NOTICE OF DECISION  
CITY OF NEWBERG, STORMWATER OUTFALL REPLACEMENT  
730/740 WYNOOSKI STREET  
STREAM CORRIDOR OVERLAY MISC223-0001

DECISION AND FINDINGS  
CITY OF NEWBERG, STORMWATER OUTFALL REPLACEMENT  
730/740 WYNOOSKI STREET  
STREAM CORRIDOR OVERLAY MISC223-0001

REQUEST: Replacement of City of Newberg Stormwater Outfall

LOCATION: 730/740 Wynooski Street

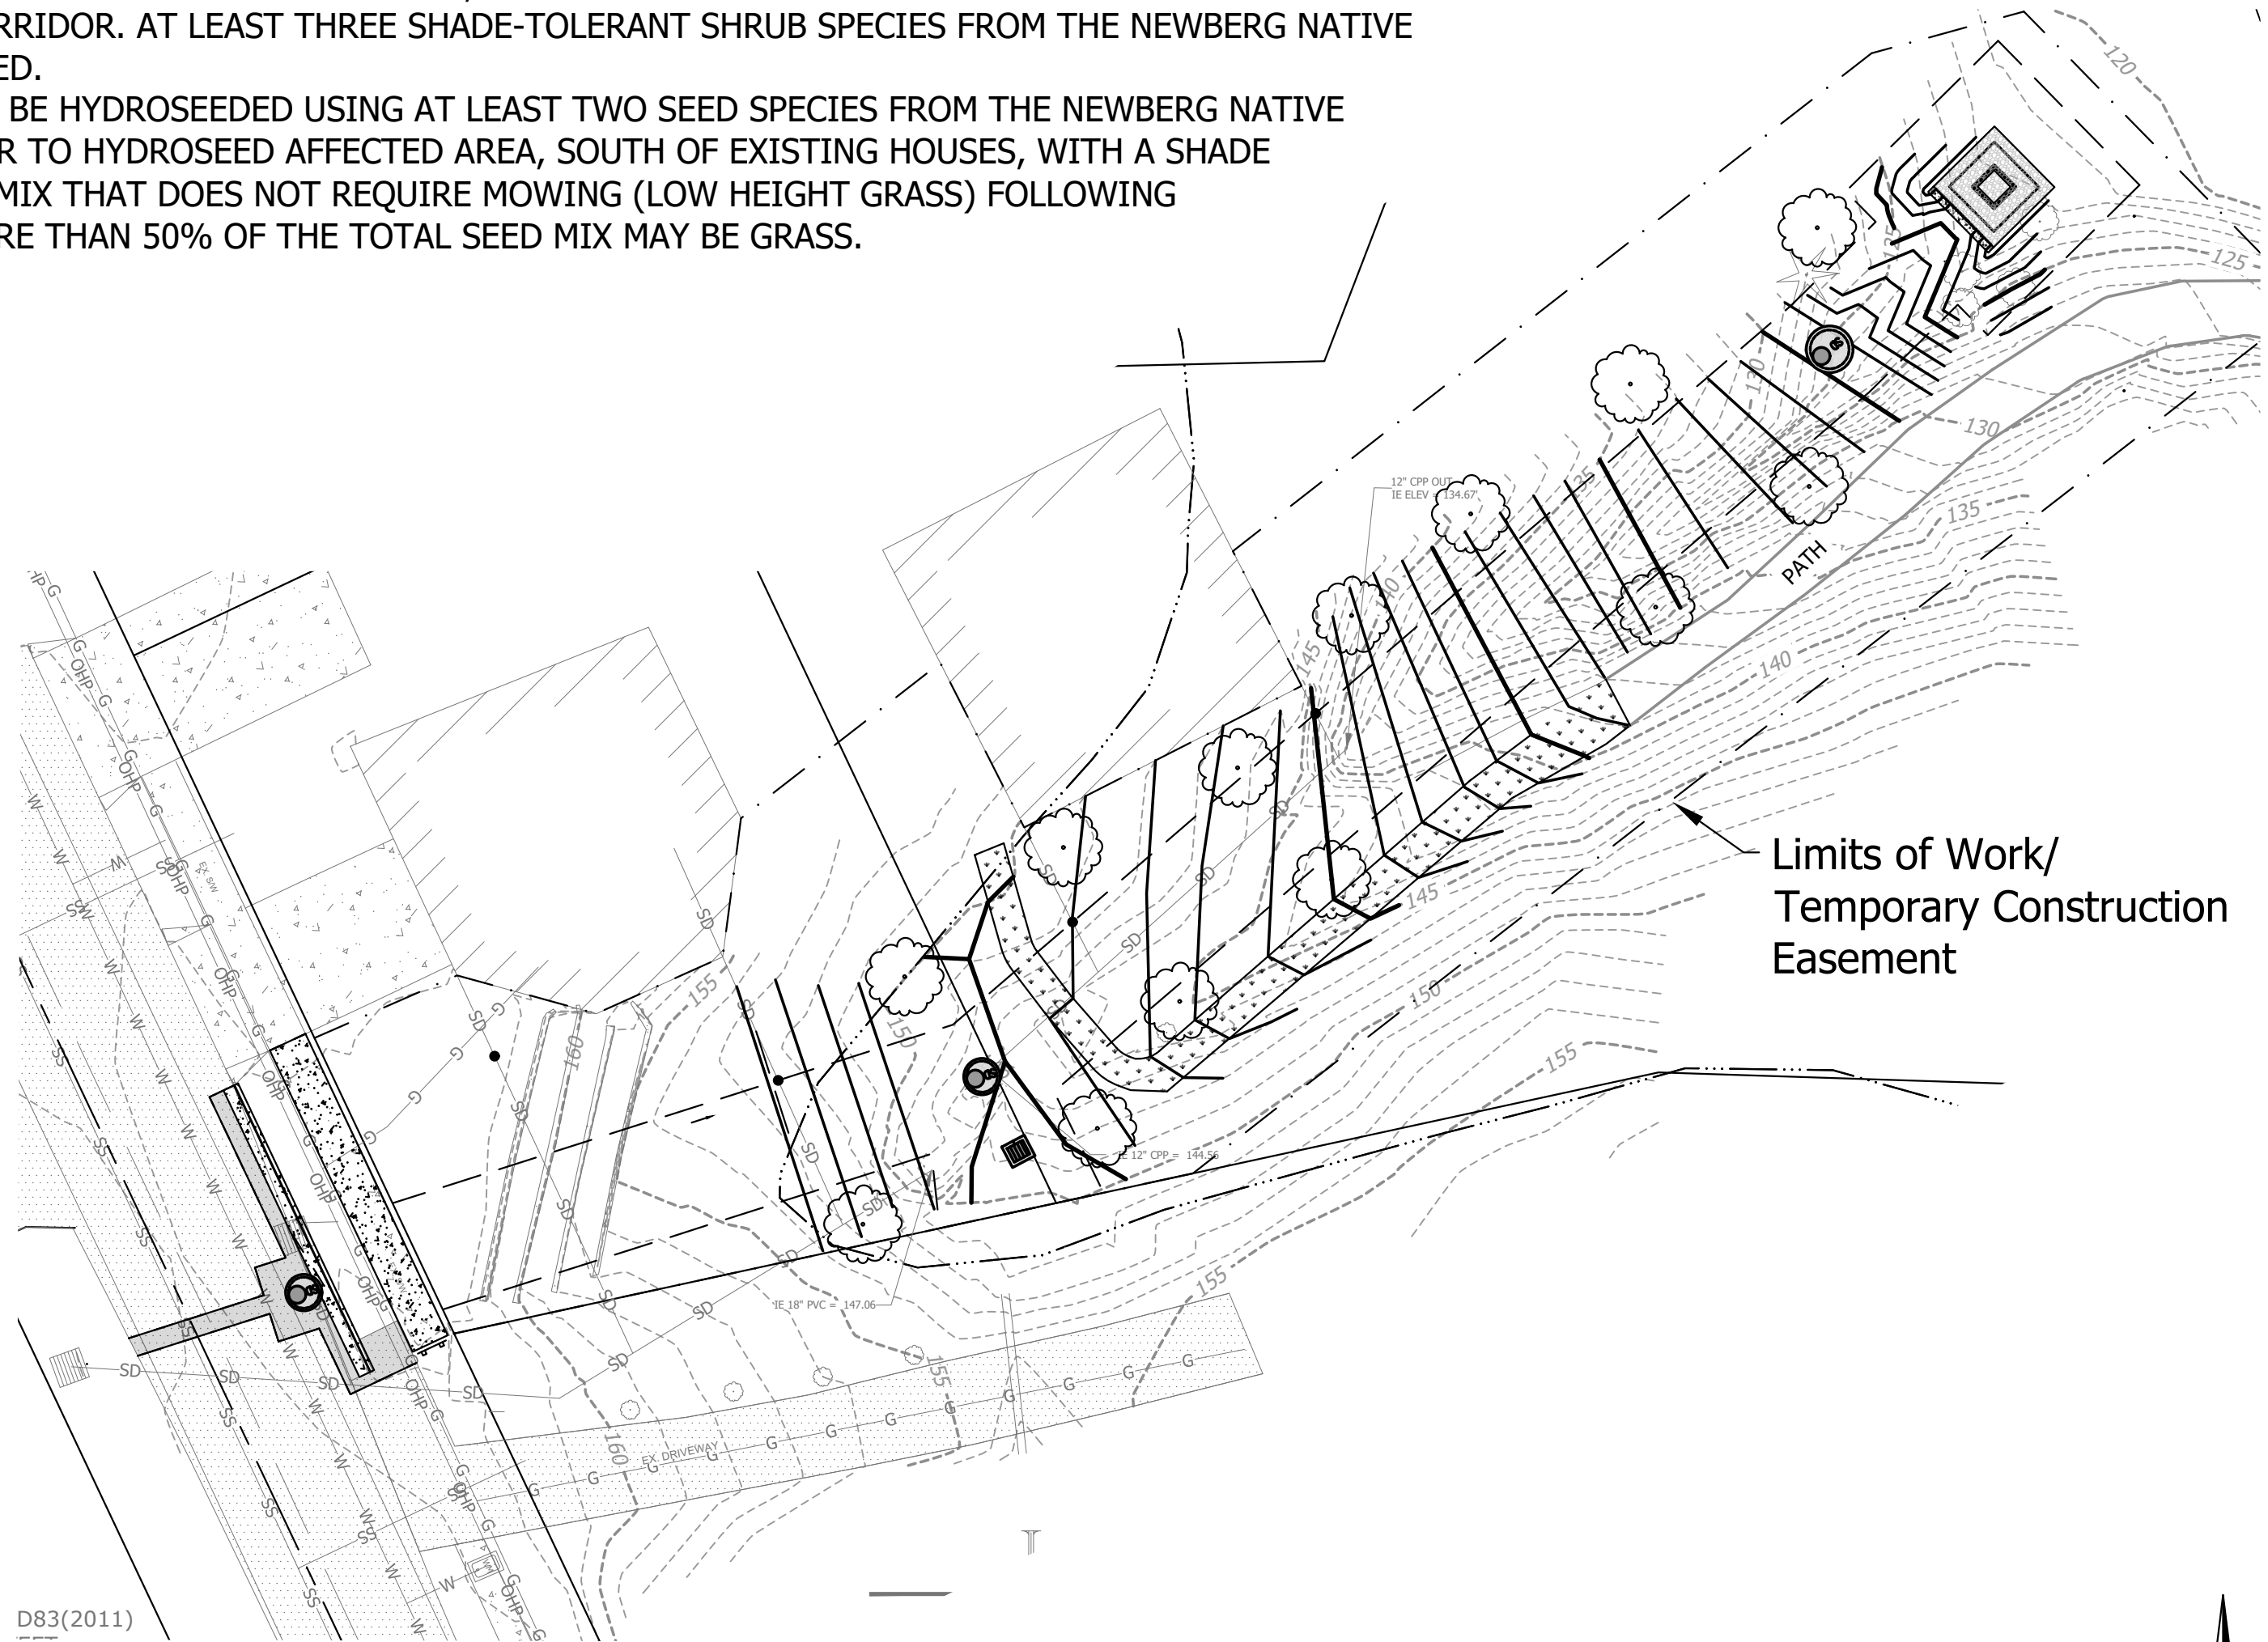
**Finding:** The Stream Corridor Mitigation Plan Sheet No. 8 of 11, General Note #3, states at least three species of trees and General Note #4 says three species of shrubs will be selected from the Newberg Native Plant List. Because the applicant does not identify which shrub species will be used from the Newberg Native Plan List, additional information is required.

The response does not properly calculate the required minimum number of shrubs. There are 25.83 500-square foot units in the 12,917 square foot disturbed area (12,917 sq. ft. / 500 sq. ft. = 25.83 units). Because three shrubs are required for each 500 square foot unit, the calculated requirement of 77.5 shrubs is rounded up to 78 shrubs as the minimum number of shrubs required. Further, the response does not address the requirement that “A minimum of one tree...shall be used for every 500 square feet of planting area.” Because one tree is required for each 500 square foot unit, 26 trees are required.

The minimum number of replacement trees required is 23 trees (8 + 15 = 23). Plan Sheet 8 of 11, Mitigation Plan, shows 15 new trees to be planted and spaced uniformly along both sides of the work area. Because a minimum of 23 new trees are required and the Mitigation Plan shows 15 new trees the applicant shall provide an updated planting plan showing a minimum of 23 trees to mitigate for the removal of existing trees pursuant to NMC 15.342.090(C). All plants must be installed prior to final planning inspection.

An updated planting plan listing the species from the Newberg Native Plant List shall be provided to the Planning Division prior to the beginning of construction. All plants must be installed prior to final planning inspection.

An updated planting plan showing a minimum of 78 shrubs and 26 trees shall be provided to the Planning Division prior to the beginning of construction. All plants must be installed prior to final planning inspection.

SHEET NUMBER  
**2 OF 11**

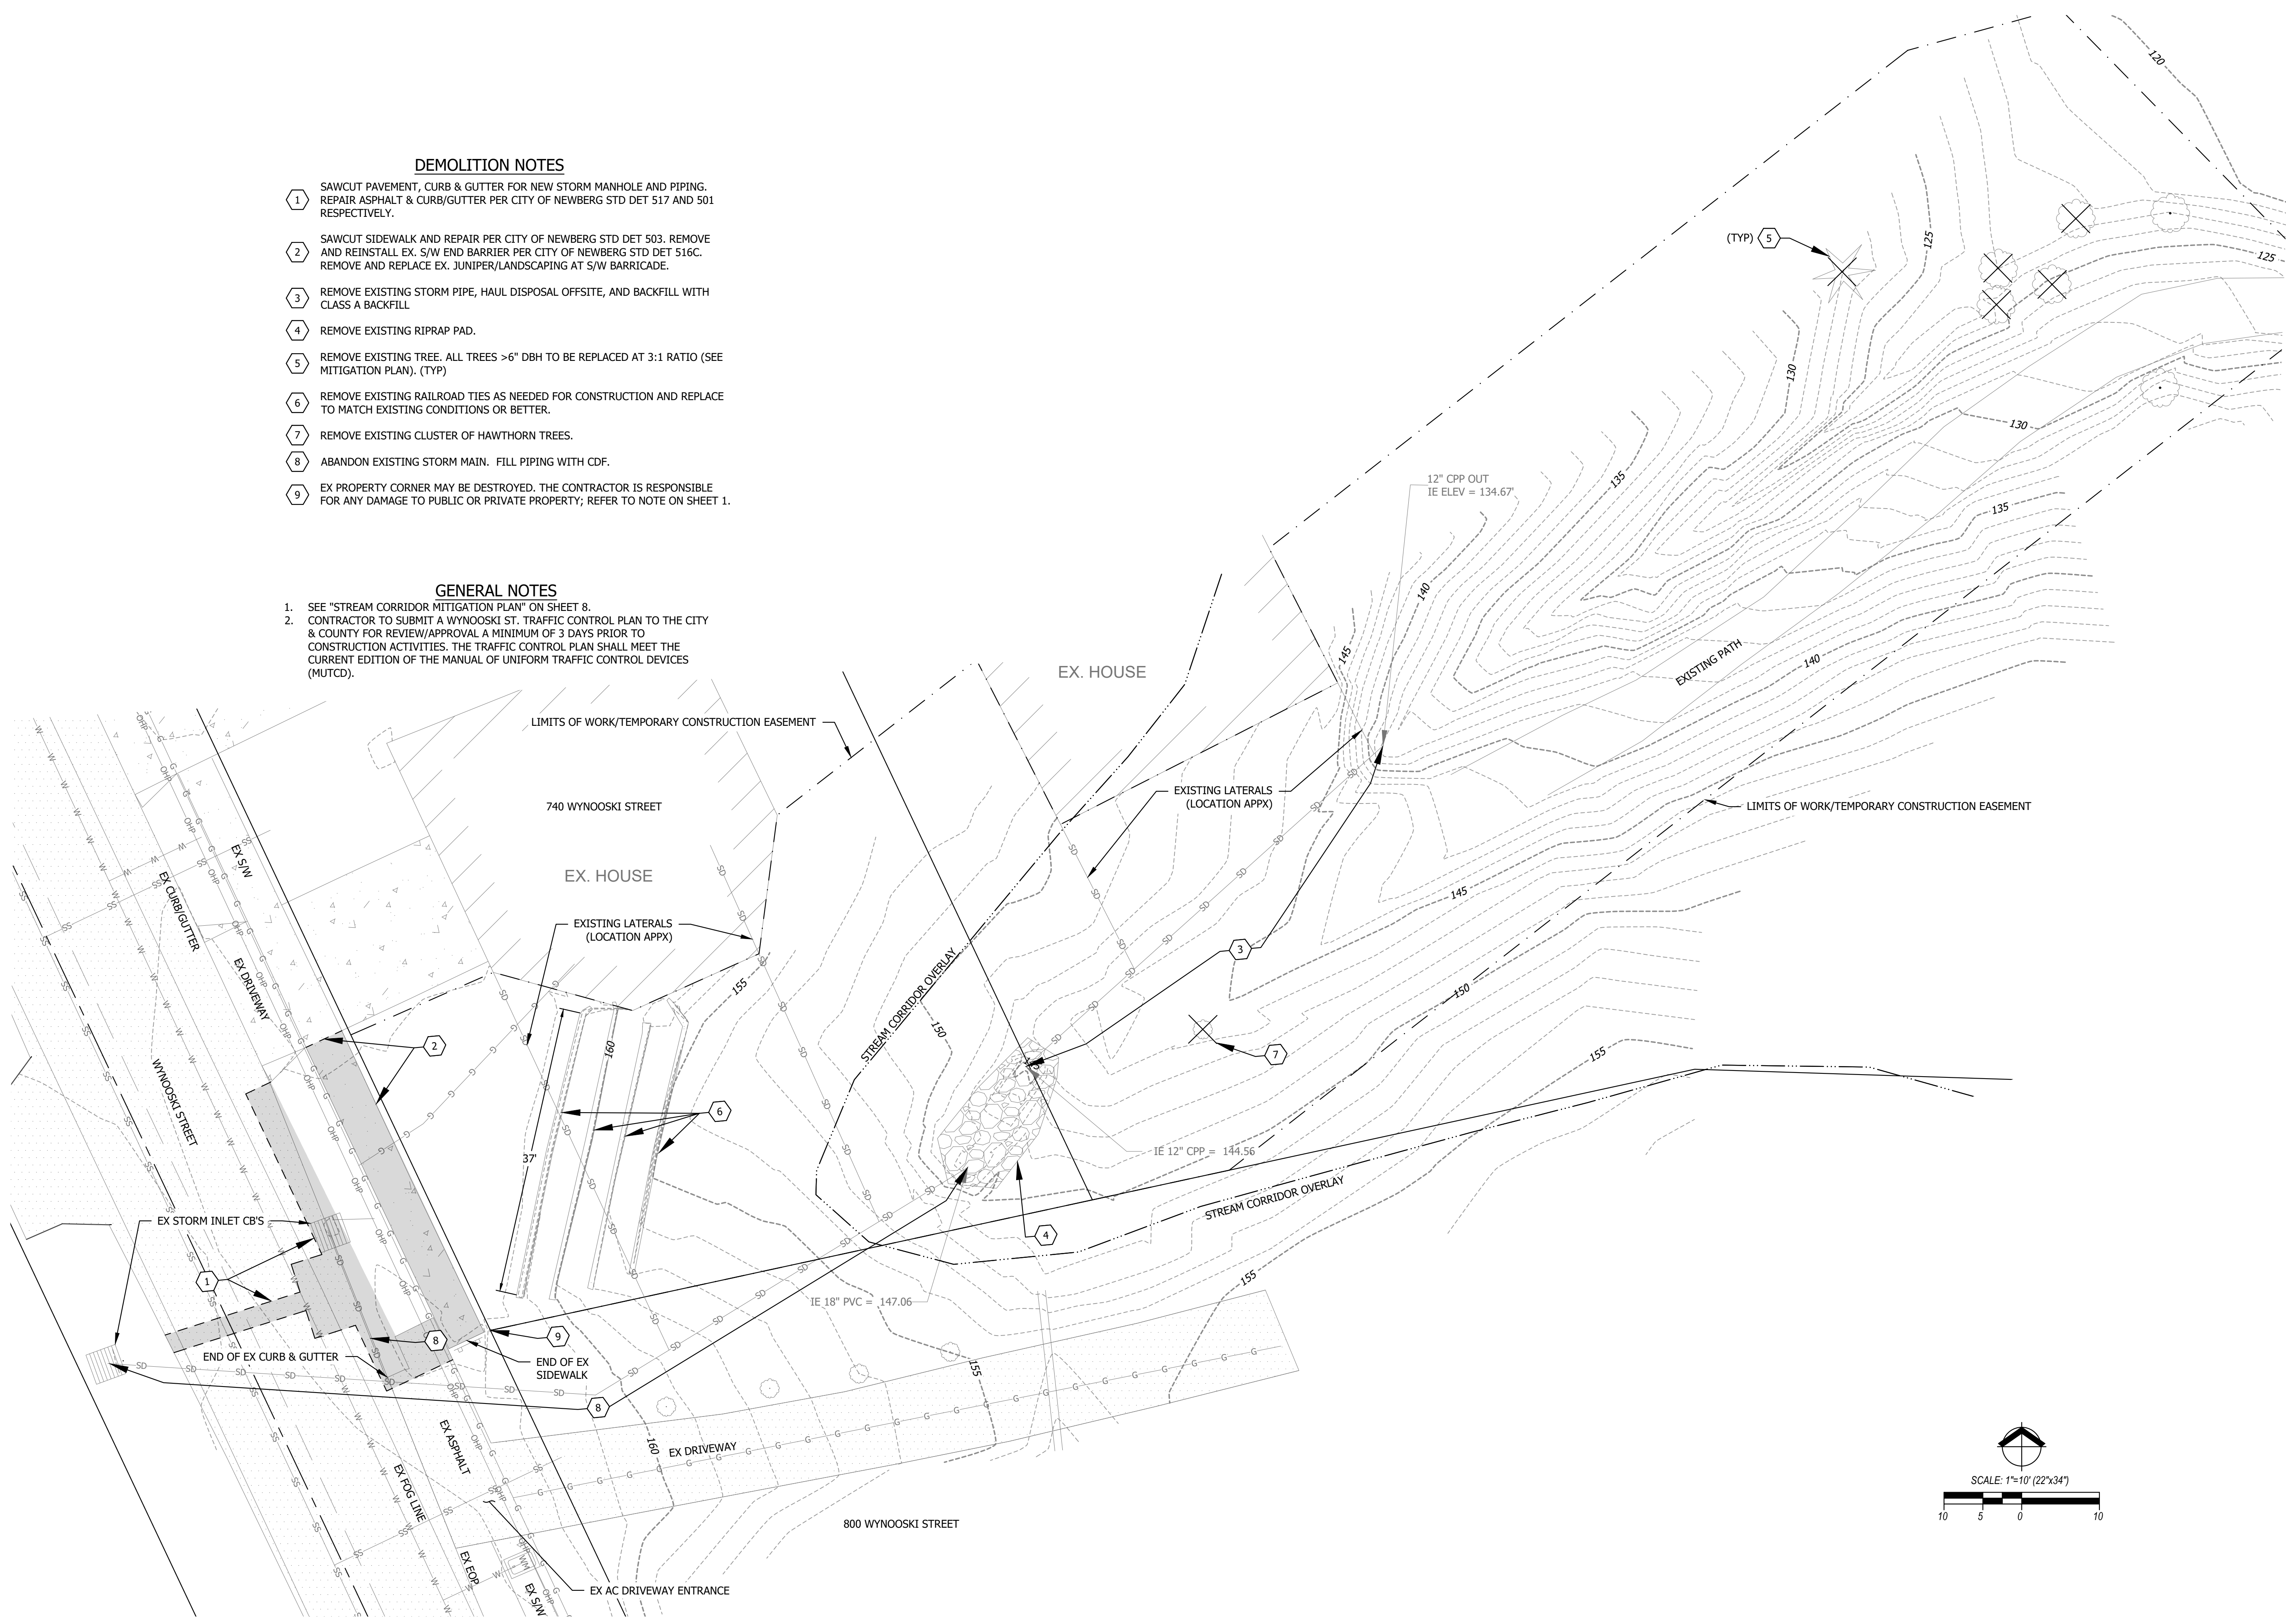
**Finding:** The approximate location of trees more than 6 inches in diameter and clusters of Hawthorne trees is shown in the December 22, 2022, HBH Consulting Engineer’s Existing Conditions Plan, Sheet 2 of 11 and the Demolition Plan, Sheet 3 of 11.

**Finding:** Project photos are included on Plan Sheet No. 2 of 11, Existing Conditions. Additional photos are included in the application materials.

F7A

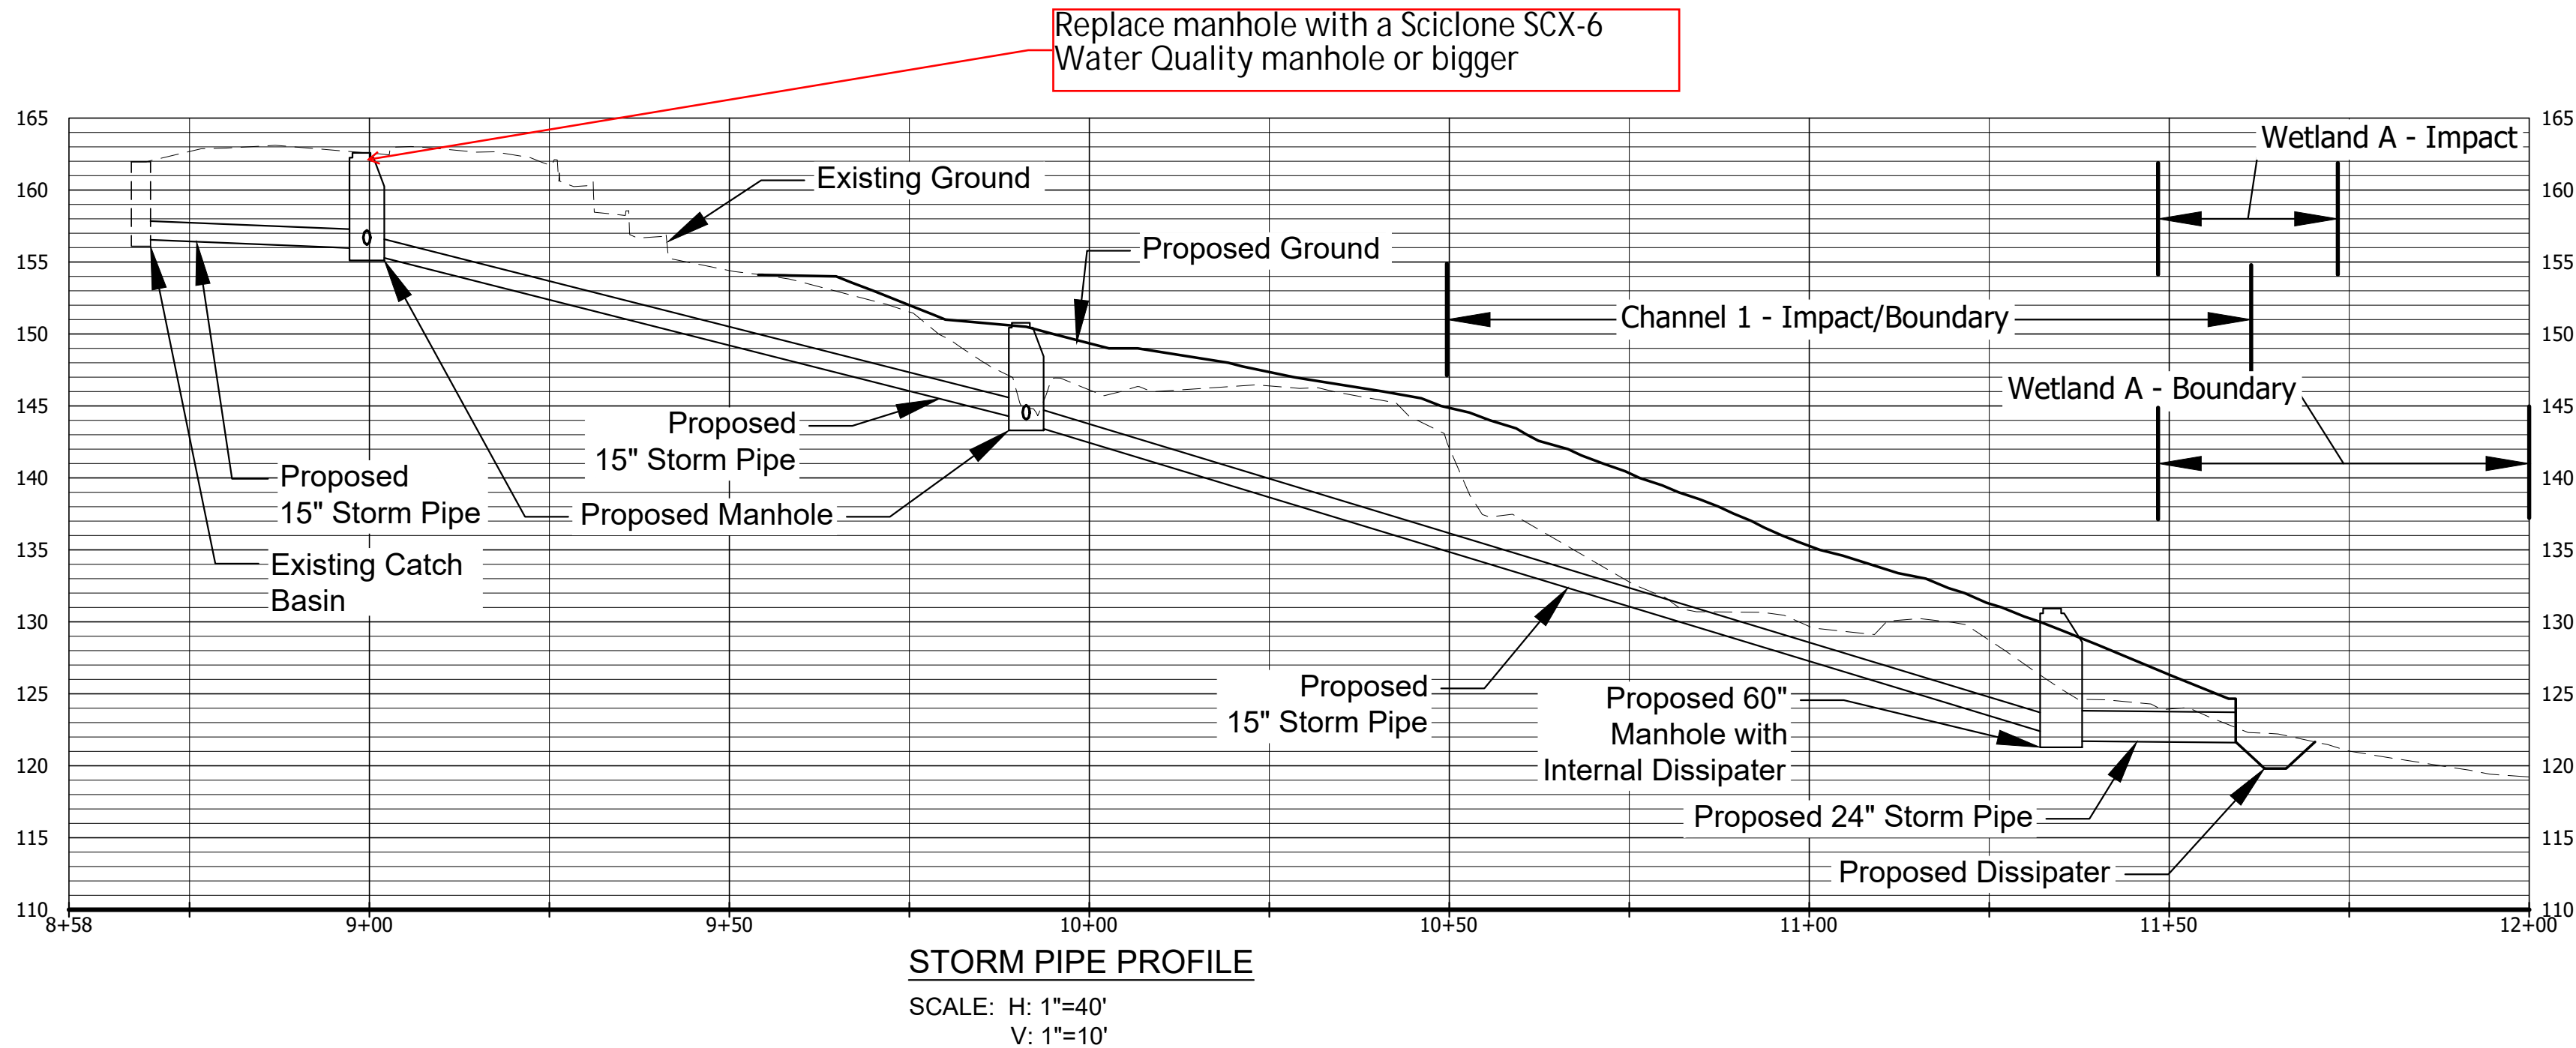
Sheet F7A of the comment depicts in red a proposed location for a “4x4 catch basin, and two hinged grates.” Sheet F5 of the comment includes a red comment box pointing to a location to “replace manhole with a Sciclone SCX-6 Water Quality manhole or bigger.”
- h. Public Works, Wastewater Treatment Plant: Reviewed, no conflict.
- i. Public Works, Water Superintendent: Reviewed, no conflict.
